ALAMEDA COUNTY
HEALTH CARE SERVICES

Subject: Fuel Case RO0002931 & Global ID # T0600174667, Shore Acres Gas,
403 E. 12th St., Oakland, CA 94606

Alameda County Environmental Health (ACEH) has reviewed the file for the subject site including the May 25, 2007 Expedited Site Assessment Work Plan Shore Acres Gas, 403 E. 12th St. Oakland, California prepared by Insight Incorporated. The work plan responds to ACEH's March 3, 2007 request for additional site characterization. Previous results from two borings advanced to a depth of 20' below ground surface (bgs) reported up to 600 parts per million (ppm) total petroleum hydrocarbons as diesel (TPHd), 3600 ppm total petroleum hydrocarbons as gasoline (TPHg), and 17, 180, 98, 440, 0.54 ppm benzene, toluene, ethyl benzene, xylenes and MTBE, respectively. Nine temporary wells are proposed for soil and groundwater sampling, then four permanent wells are proposed after groundwater gradient has been determined. The temporary wells would then be properly decommissioned. Prior to performing this work, we request you address the following technical comments and submit the requested technical report.

Figure 2
SITE PLAN WITH BORING LOCATIONS
 Shore Acre Gas
 403 E 12th Street
 Oakland, California

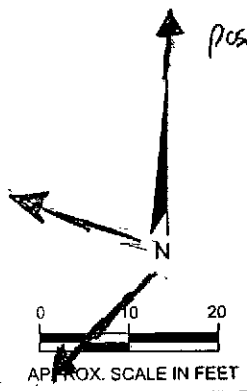
- The borings should be placed and sampled to determine the lateral and vertical extent of contamination. Assuming a generally westerly gradient (possibly northwest or southwest), the borings should be placed in a transect down-gradient and perpendicular to the source(s). The potential sources at this site are the USTs and the pump islands. Attached please find a site plan with boring locations noted in this type of array.

Enclosure- revised boring locations
